VCBO® ADDENDUM 001

project	Intermountain Healthcare PKH CT Remodel	project no	22545
date	2024-01-11	no. pages	
owner	Intermountain Healthcare		
contractor			
bid date	2024-01-19	bid time	4:00 pm

C3 CT PROCEDURE - DEMOLITION PLAN
SCALE: 1/4" = 1'-0"

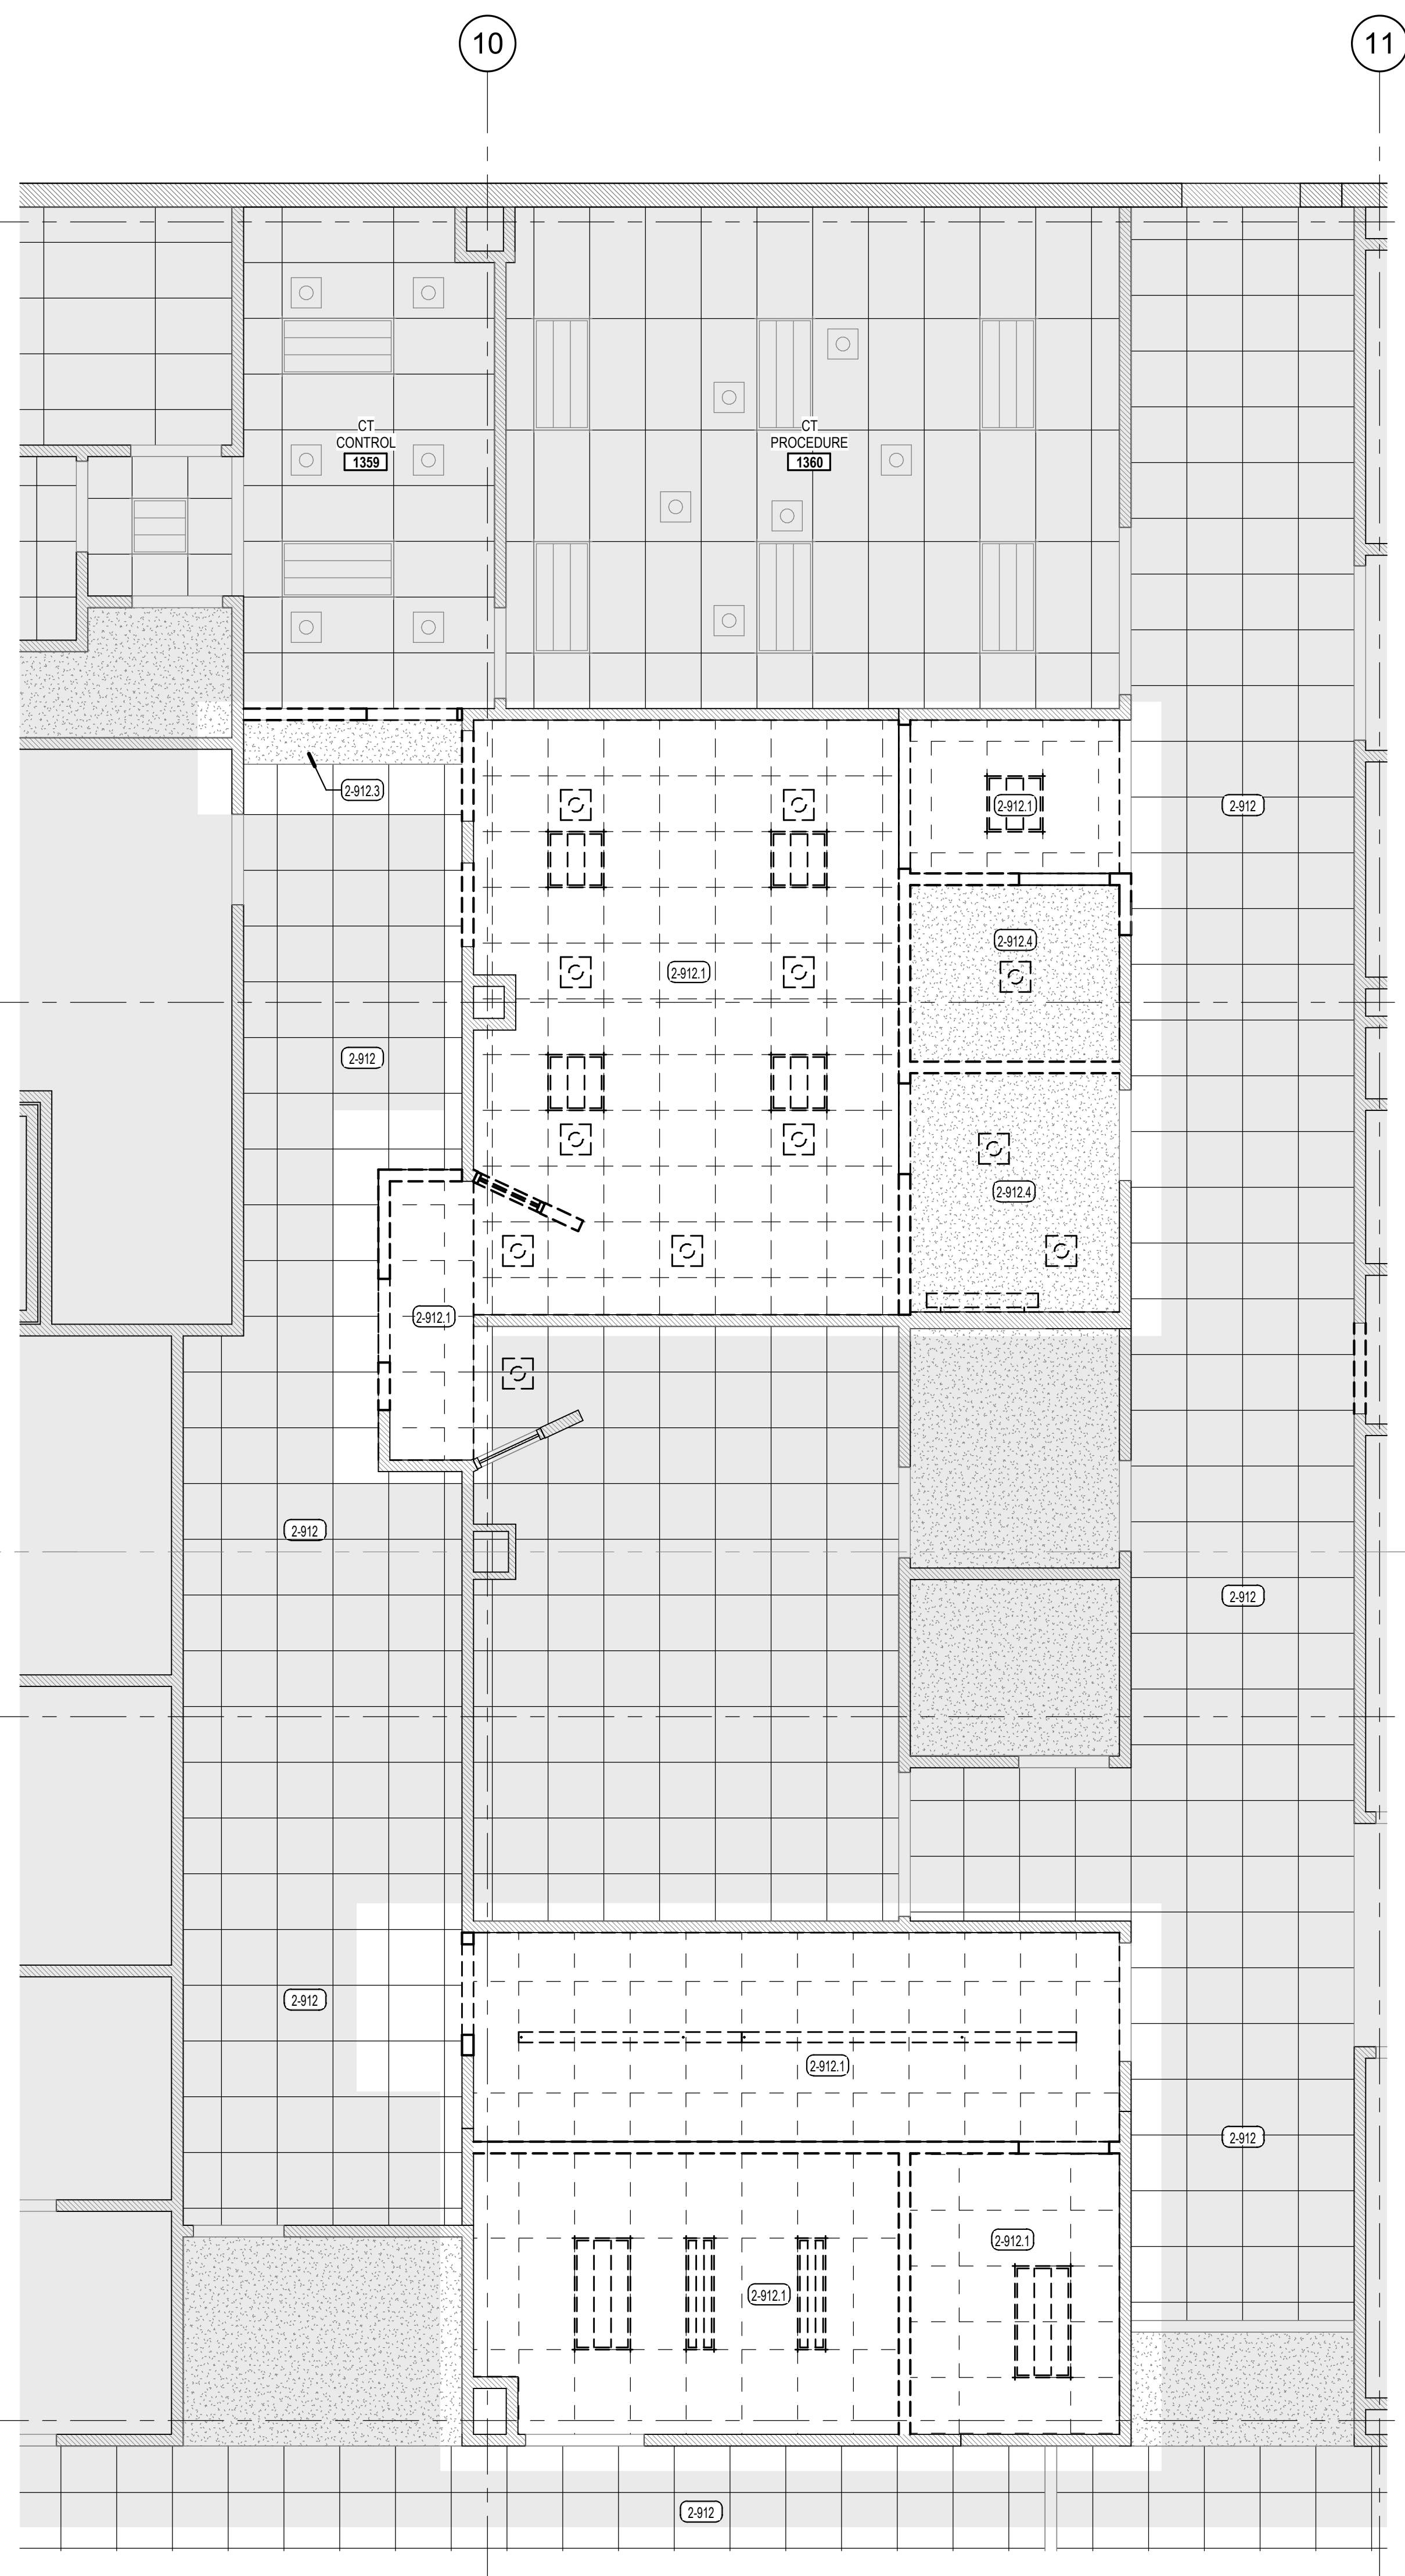
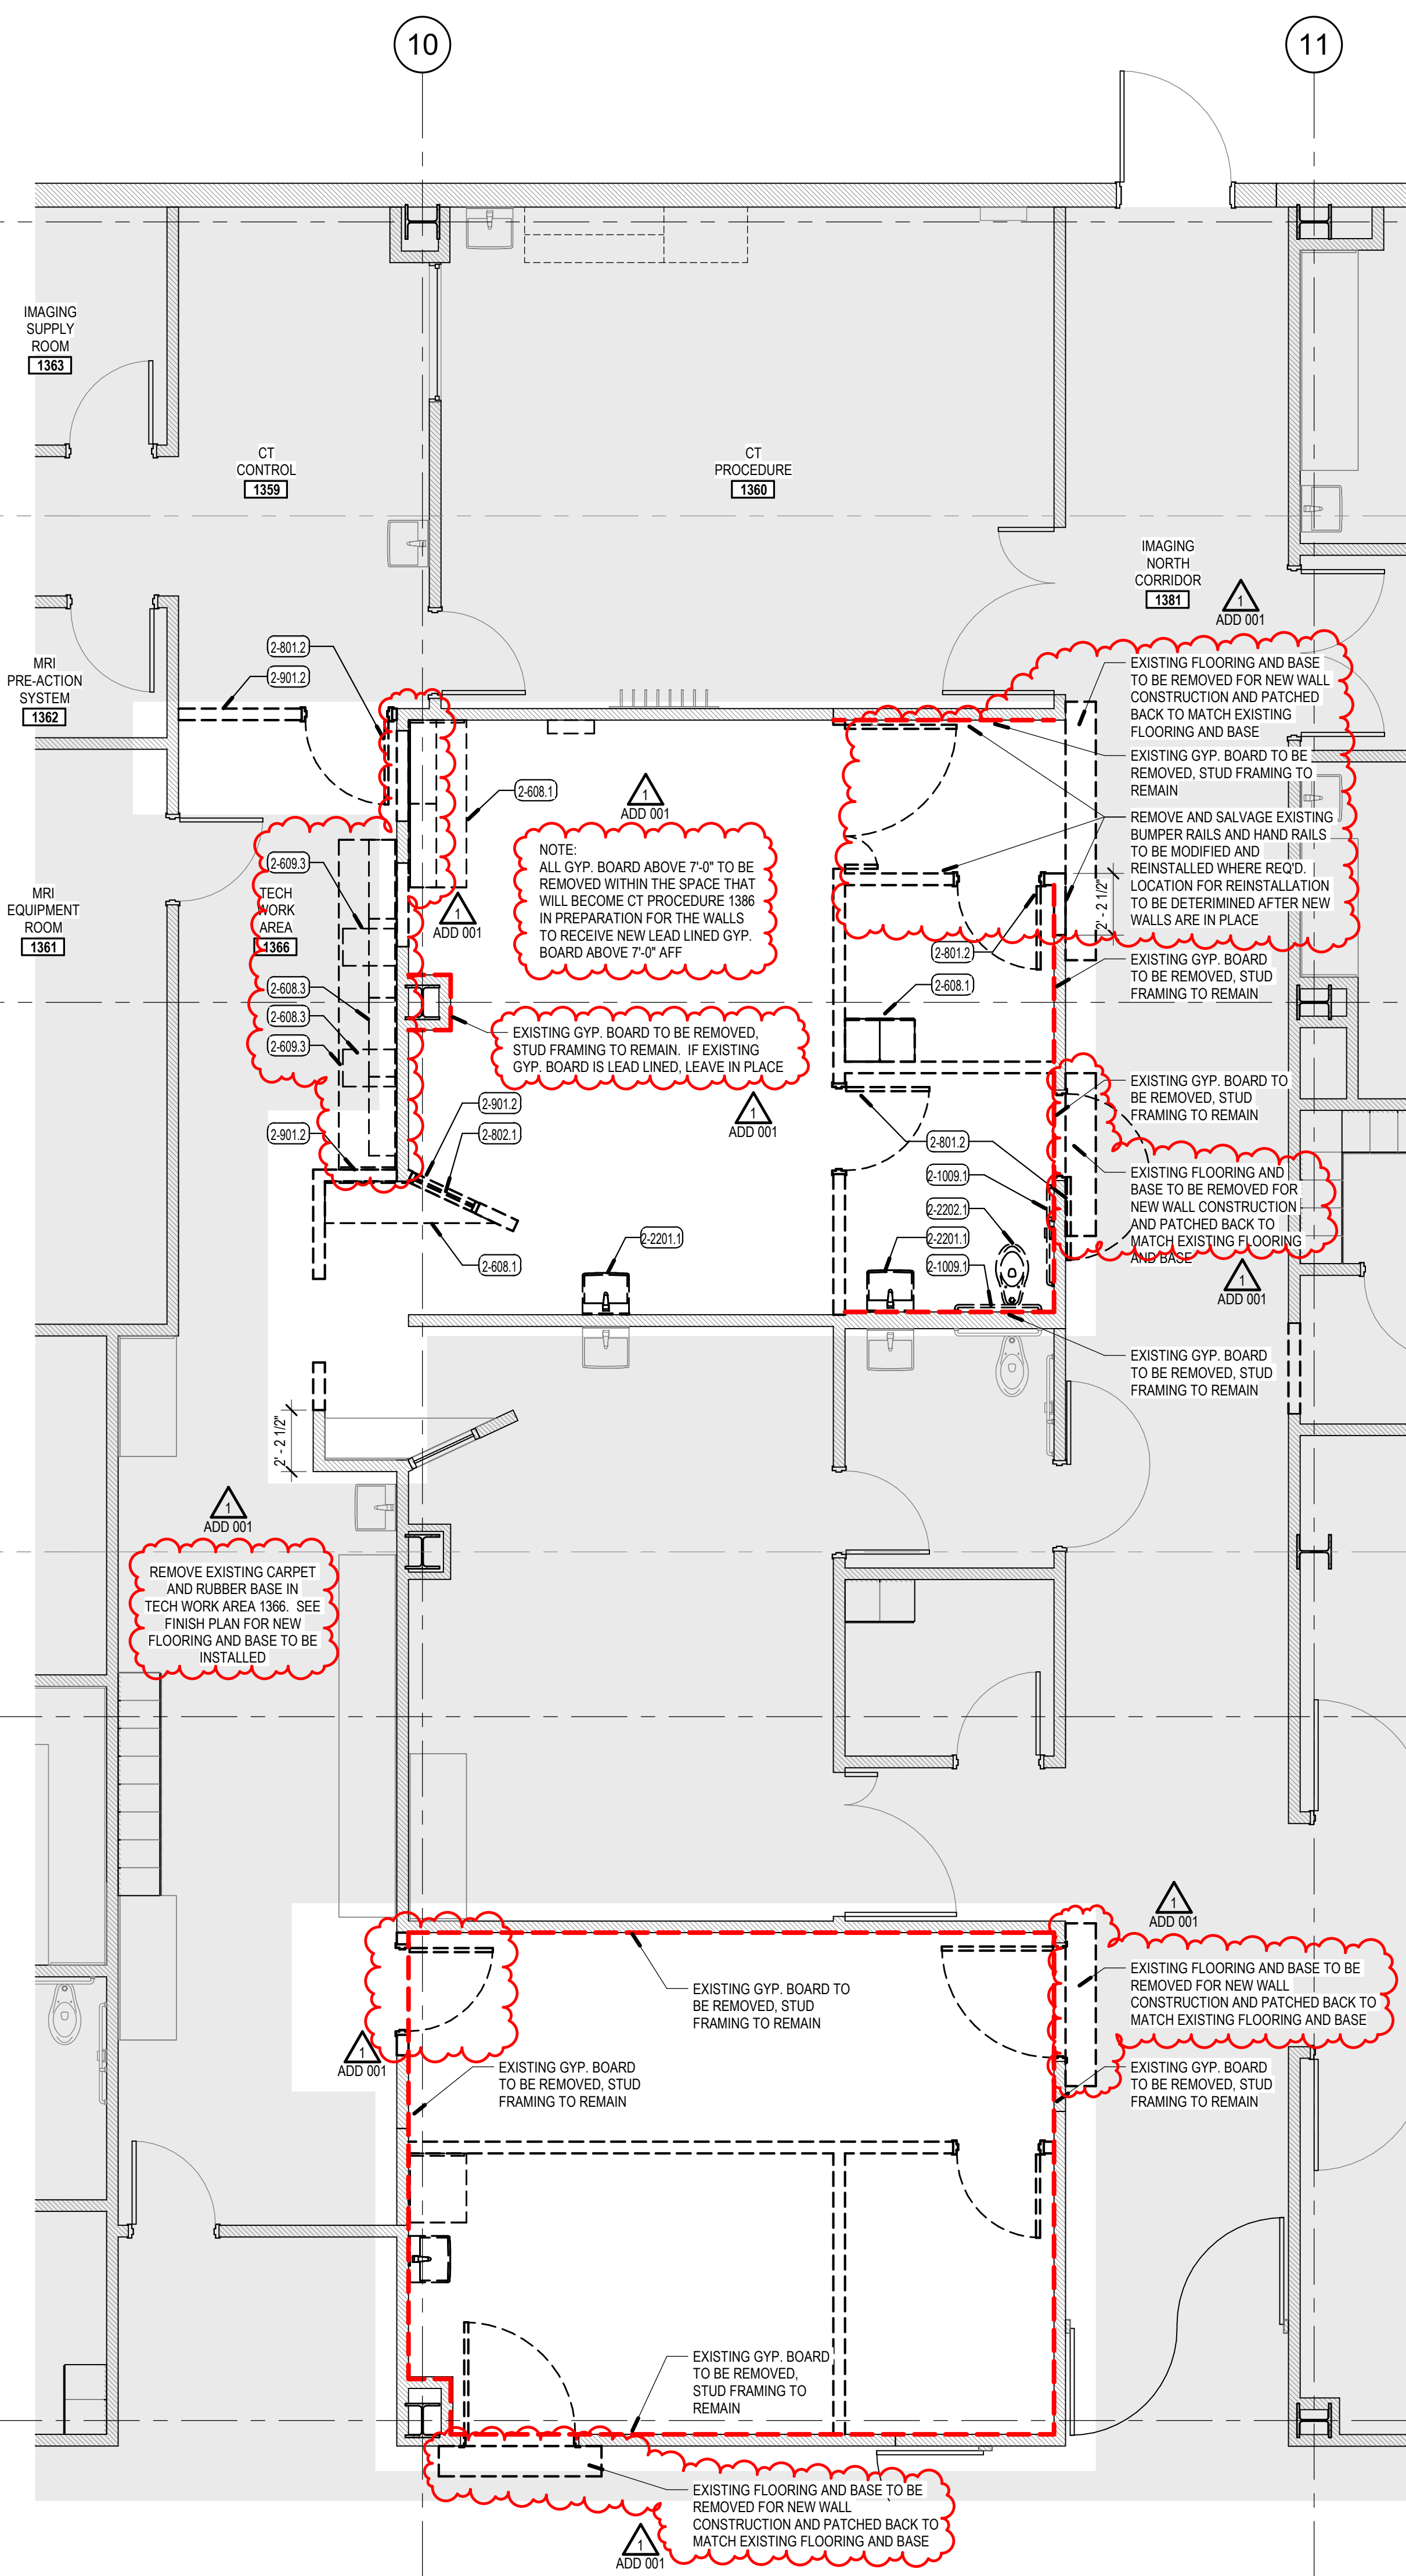
item	sheet#	description
1.1	AD110	FIRST FLOOR - DEMOLITION PLAN & DEMOLITION RCP <ol style="list-style-type: none">1. ADD TEXT NOTES EXISTING FLOORING AND BASE TO BE REMOVED FOR PATCHING AT NEW WALLS AS CLOUDED.2. ADD TEXT NOTE TO REMOVE FLOORING AND BASE IN TECH WORK AREA.3. ADD NOTES AND SHOW RELOCATION OF EXISTING MILLWORK IN TECH WORK AREA.4. ADD UPPER CABINETS IN FUTURE CT PROCEDURE 1386 TO BE REMOVED.5. ADD NOTES FOR GYP. BOARD DEMO CLARIFICATION IN FUTURE CT PROCEDURE 1386.6. ADD NOTE FOR EXISTING BUMPER RAILS AND HANDRAILS IN THE ENTRY CORRIDOR TO THE EXISTING FLUOROSCOPY ROOM.

OVERALL SITE PLAN

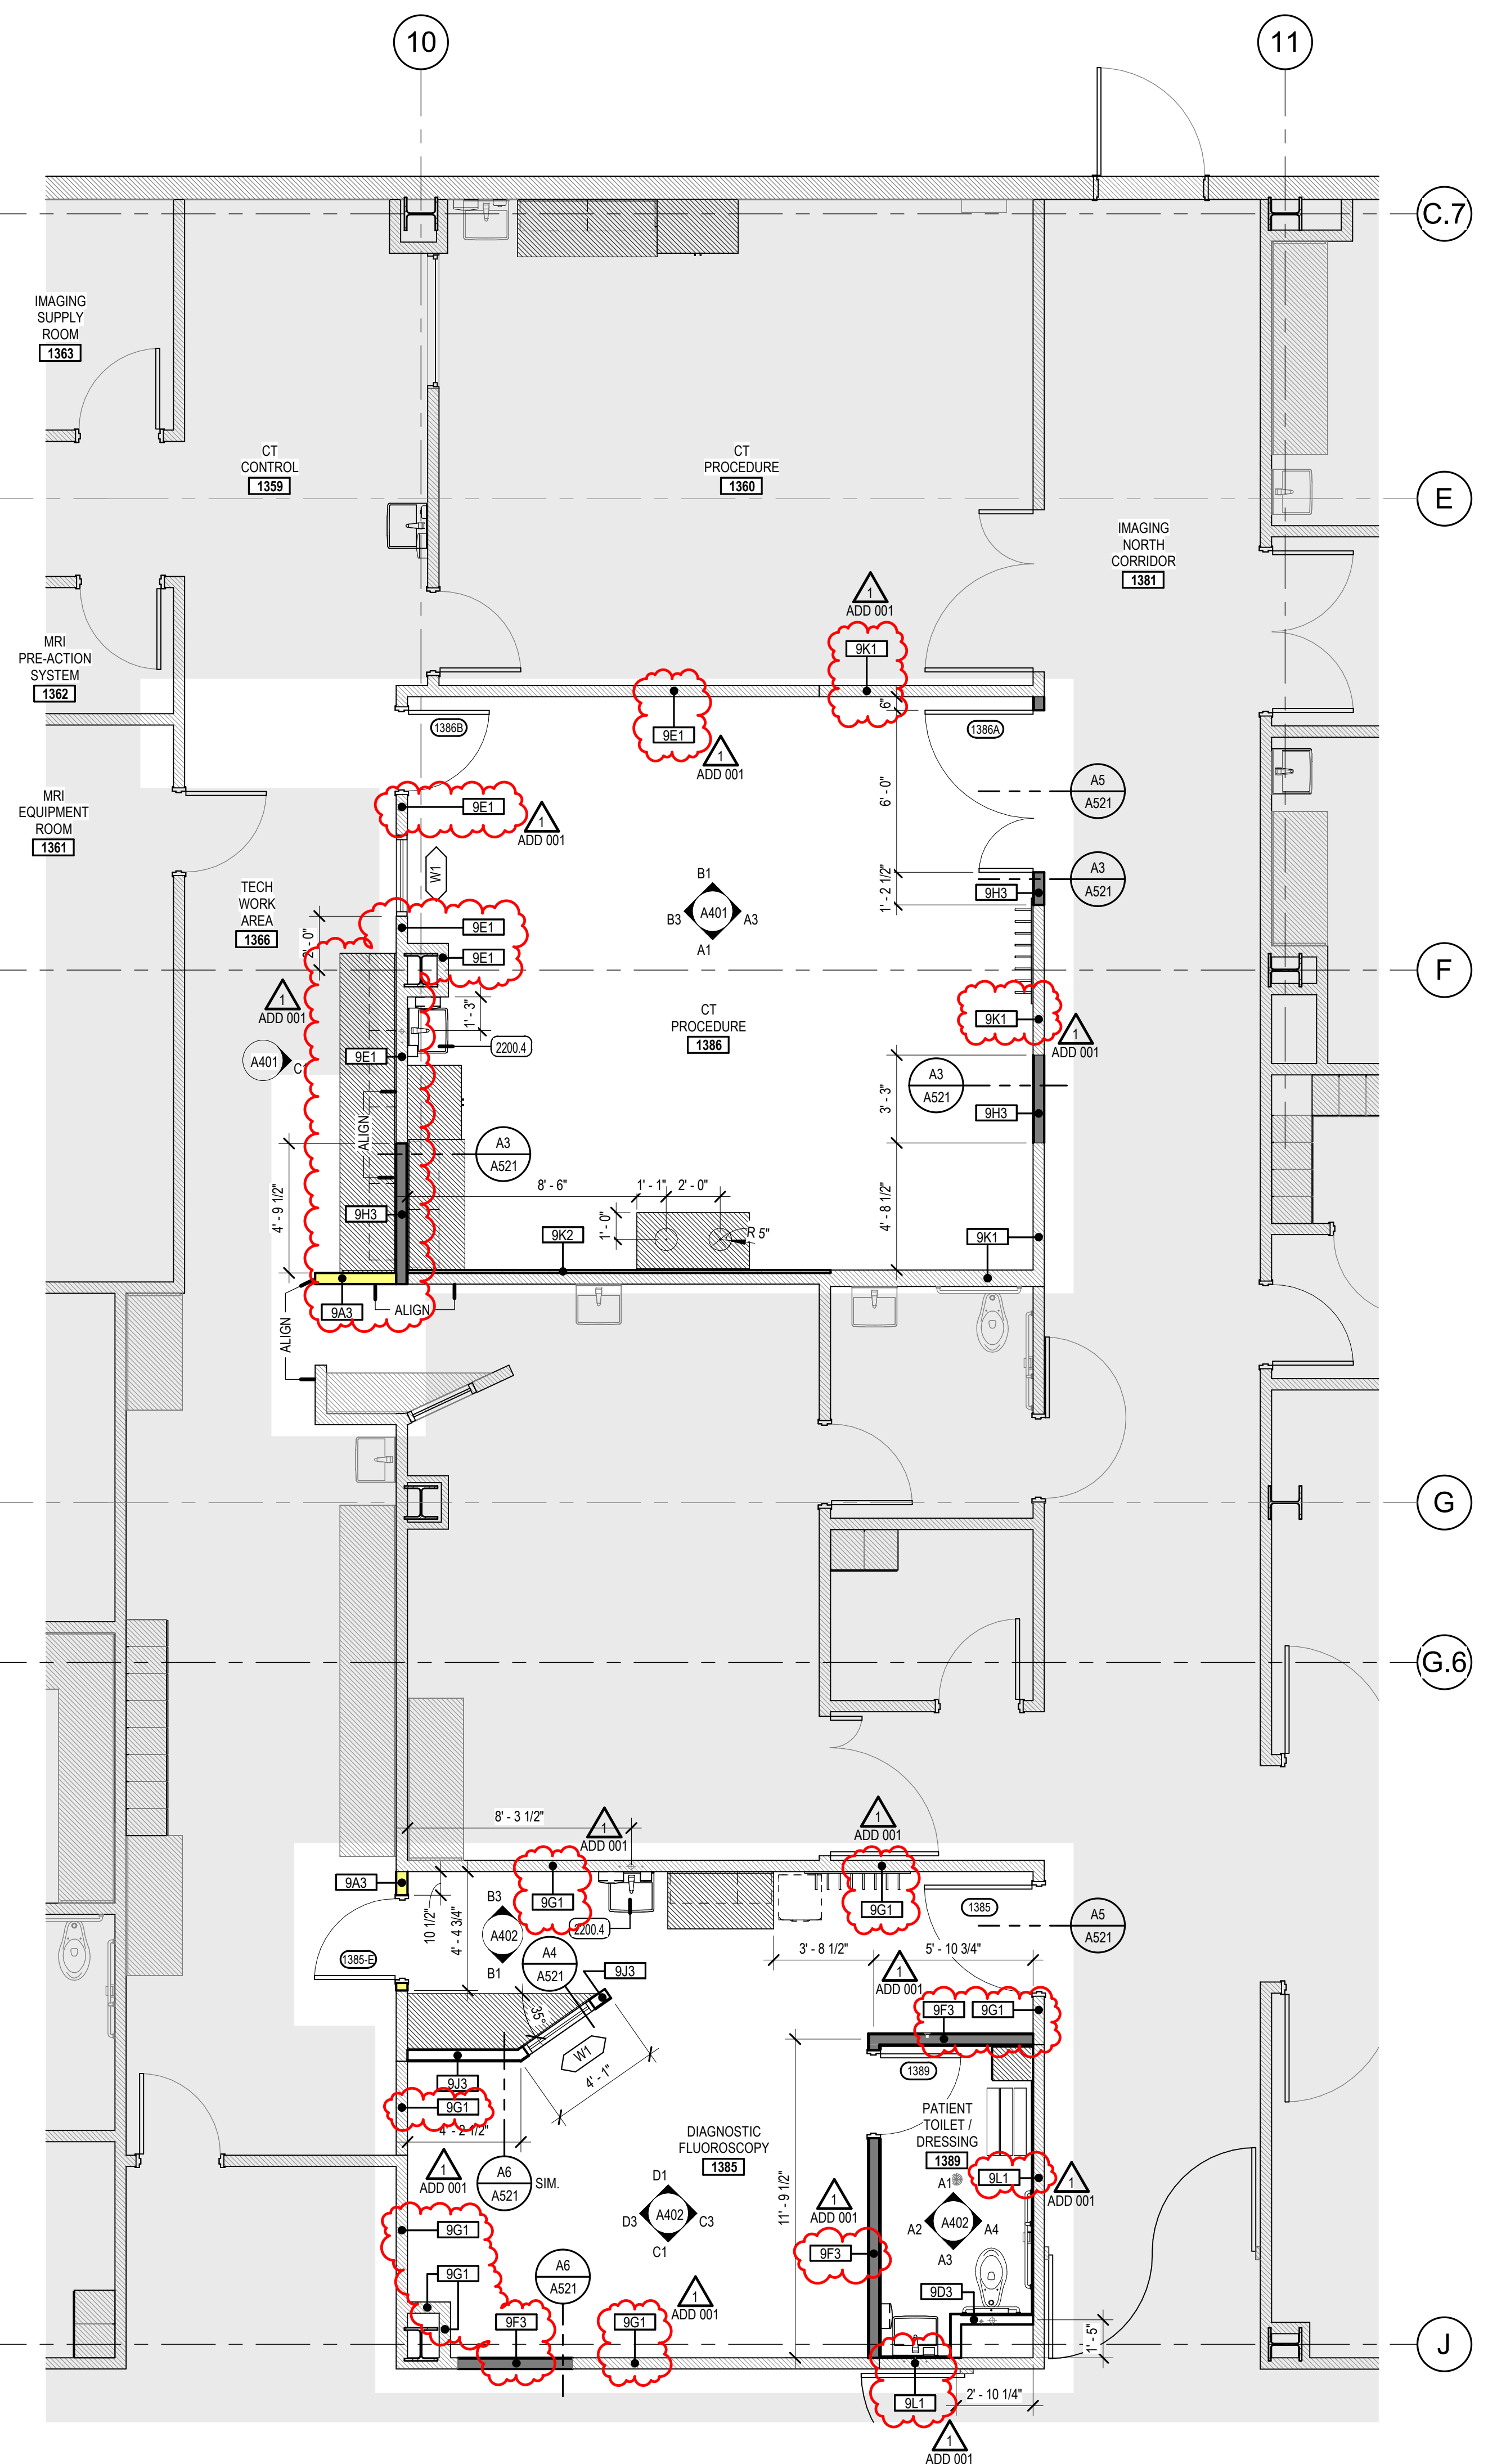
1.2	AS101	OVERALL SITE PLAN <ol style="list-style-type: none">1. REVISED LOCATION OF PROJECT WITHIN THE EXISTING BUILDING AS CLOUDED.
1.3	A110	FIRST FLOOR - SLAB PLAN, ANNOTATED & DIMENSION PLAN <ol style="list-style-type: none">1. ADD NOTES FOR SLAB CUTTING AS CLOUDED.2. REVISED WALL TYPES AS CLOUDED.3. ADD EXISTING COUNTERTOP AND MILLWORK TO BE RELOCATED IN TECH
